Mould 849

Mould 857

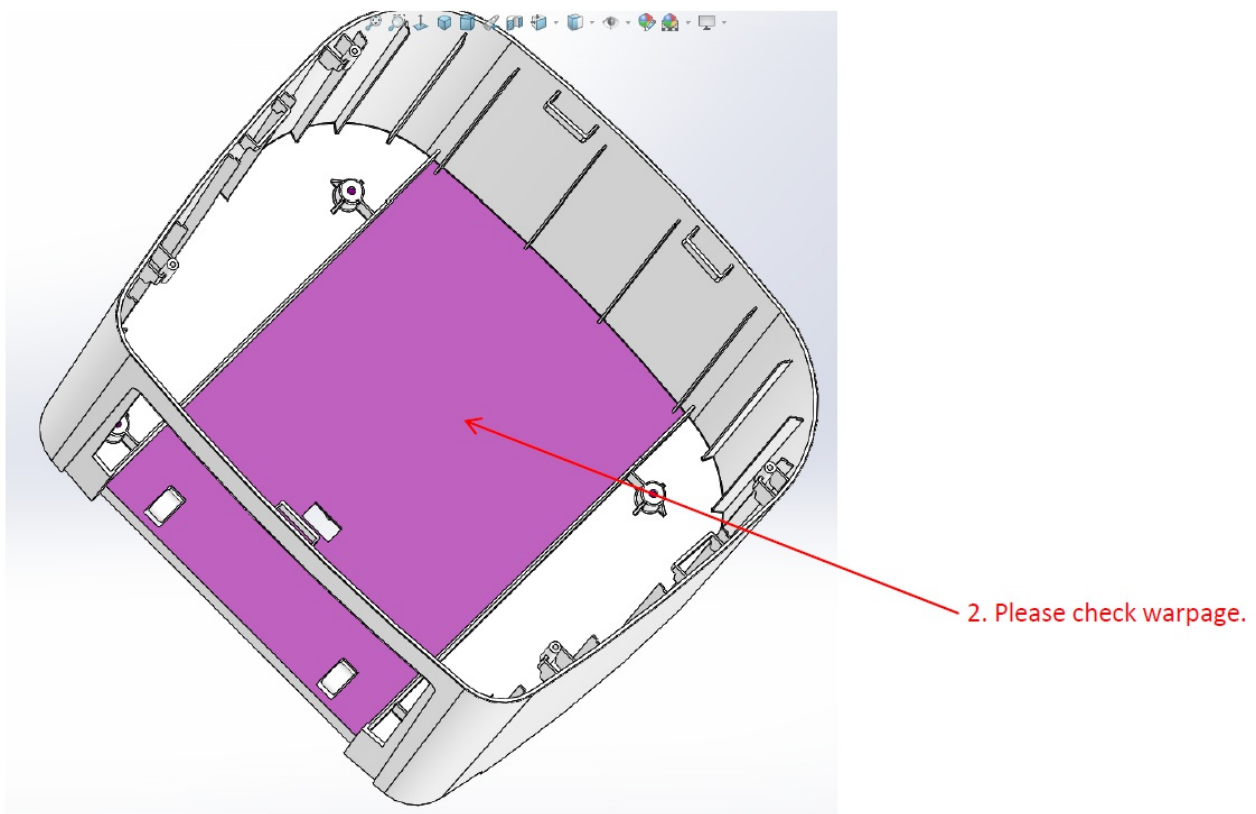
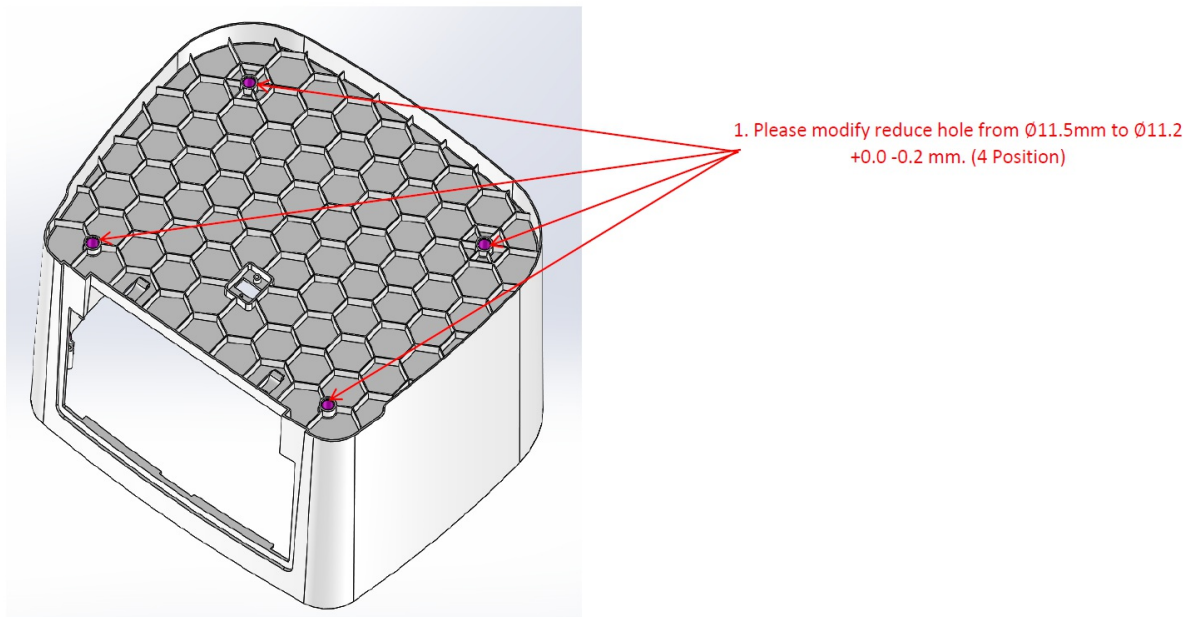
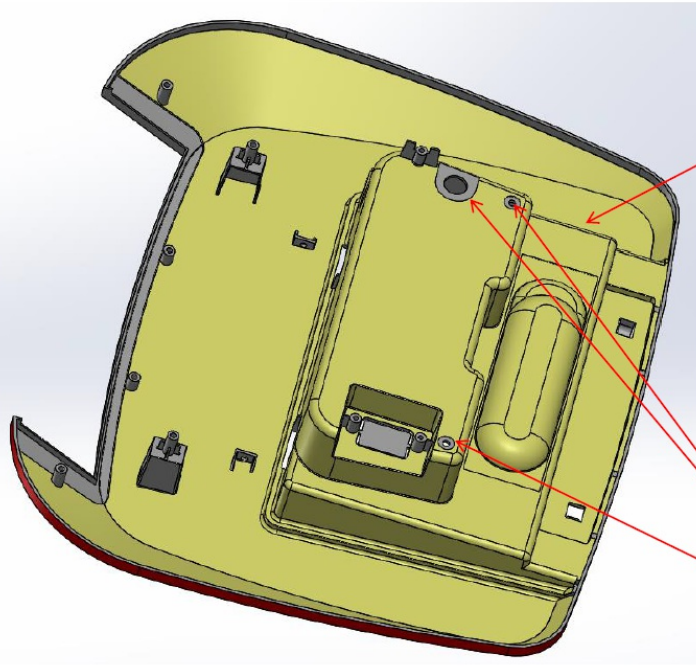
1. Modify the hole size from a diameter of 11.5mm to 11.2mm
2. increase venting at the top weldline
3. fix flashing between inserts

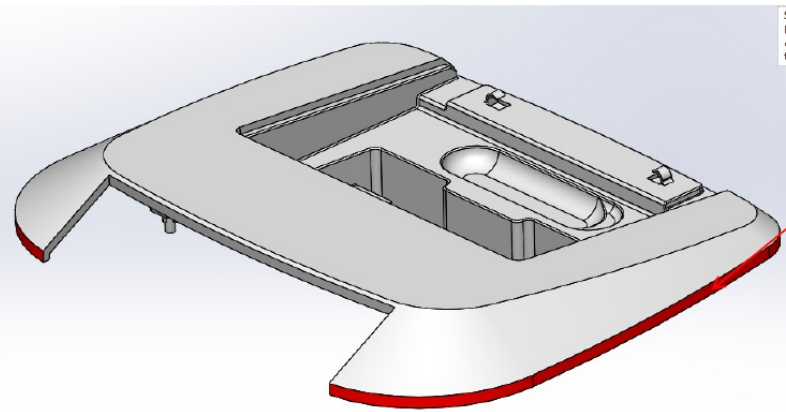
1.Add thickness from 2.0 mm to 2.5 mm.

2.Please modify add thickness according to drawing. SAMXXB-857 Rev05 (Top cover AC Classic2)

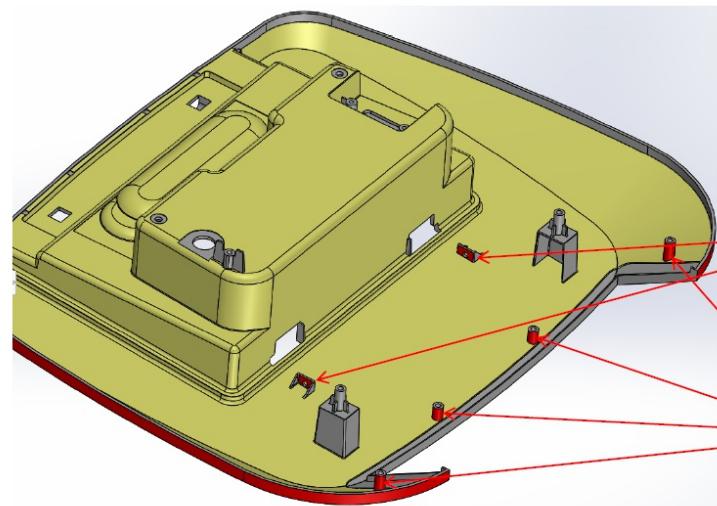
3.Surface around dimension not according to drawing please modify (offset around 0.25 mm.)

4.Please reduce thickness to 1.6 mm. 2 Position according to drawing. SAMXXB-857 Rev05 (Top cover AC Classic2)

5.Please reduce thickness to 1.6 mm. 4 Position according to drawing. SAMXXB-857 Rev05 (Top cover AC Classic2)

1. we dont need to modify the part because we modify another part instead
2. reduce thickness from 1.8mm to 1.6mm --> confirmed
3. reduce thickness from 1.8mm to 1.6mm --> confirmed
4. change the parting line --> confirmed

Mould 858

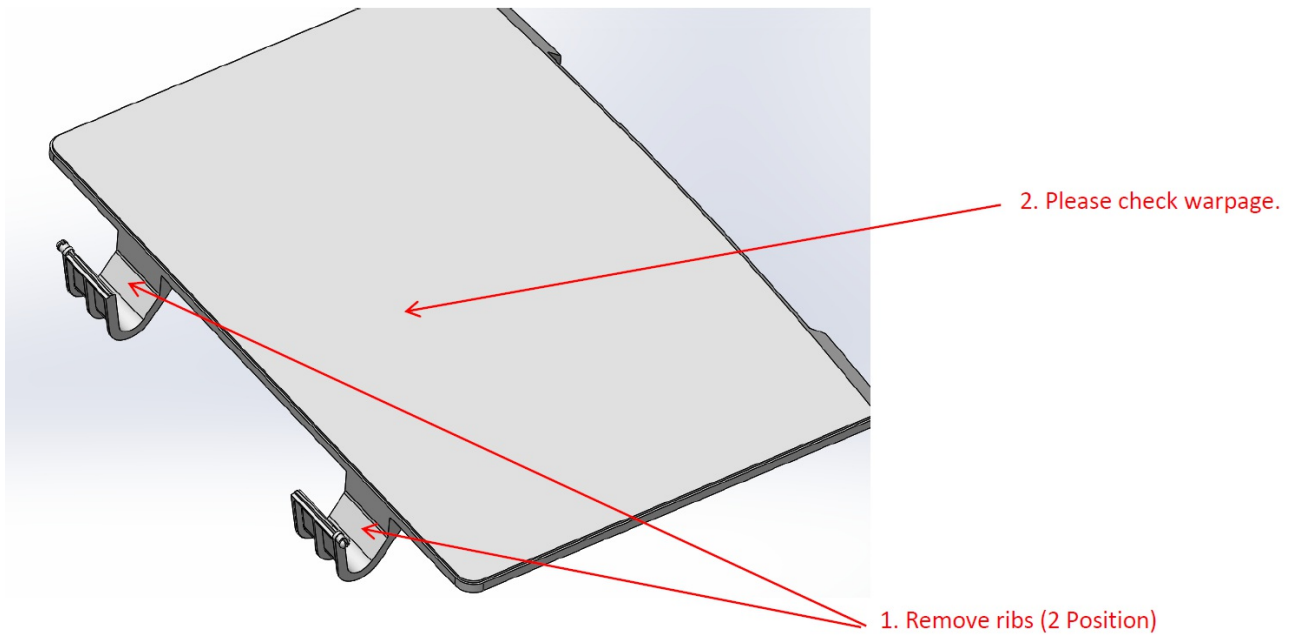
Description wire cover lid

1. remove ribs (2 positions) around the closing mechanism
2. the ribs dimensions behind the part is actually ok
3. add 10% to gate thickness

Mould 859

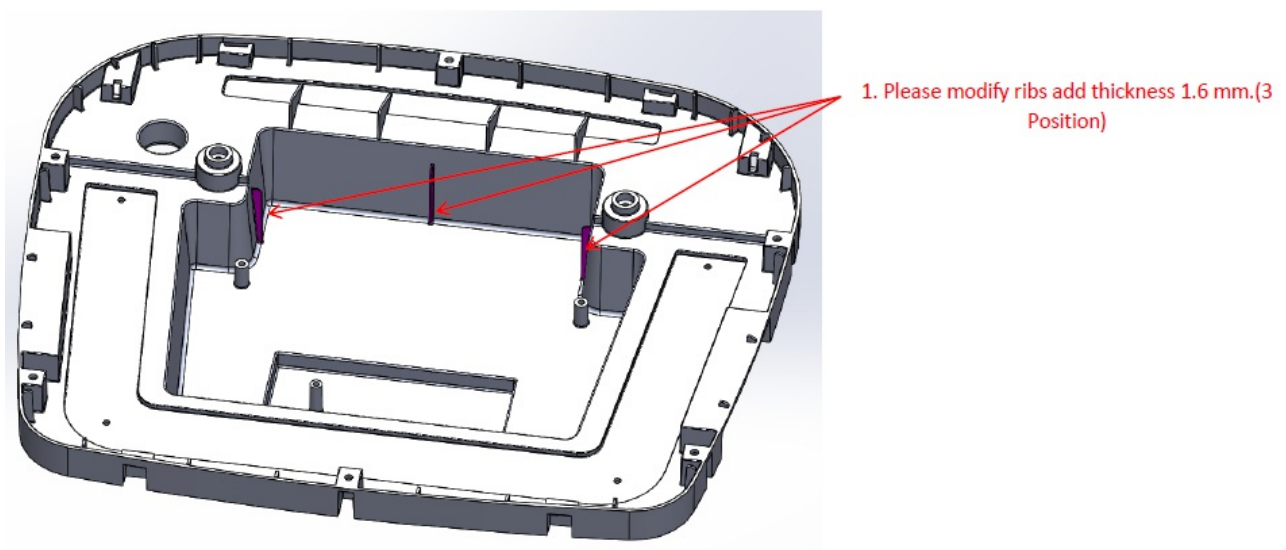
1. change ribs thickness to 1.6 mm

1. add venting and ribs change to 1.6mm
2. adding cooling channels for the hotspot --> confirmed

Mould 864

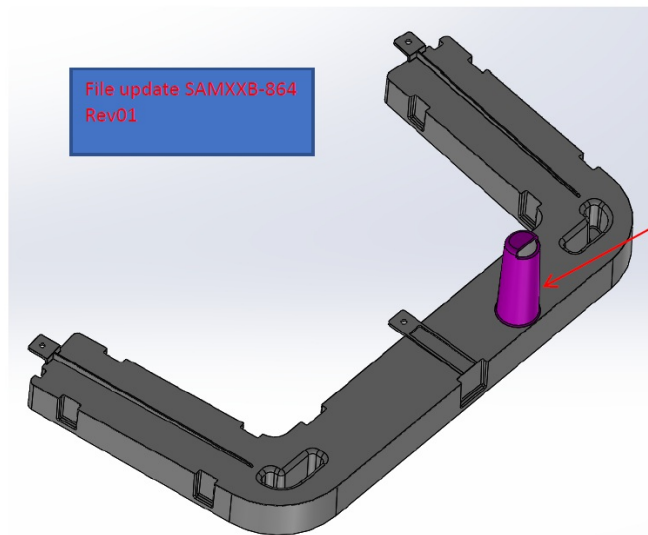
1. remove both drainage channel inserts and modify into 1 single circular drainage channel. The cooling channel should be a bubbler and should be as large as possible (at least 10 mm)

1. Add more venting --> confirmed
2. cooling channel in original design: --> This is too risky from the mechanical strength perspective. Also it is likely that the channel is too small and will make the flow lamina which is bad for the heat removal.
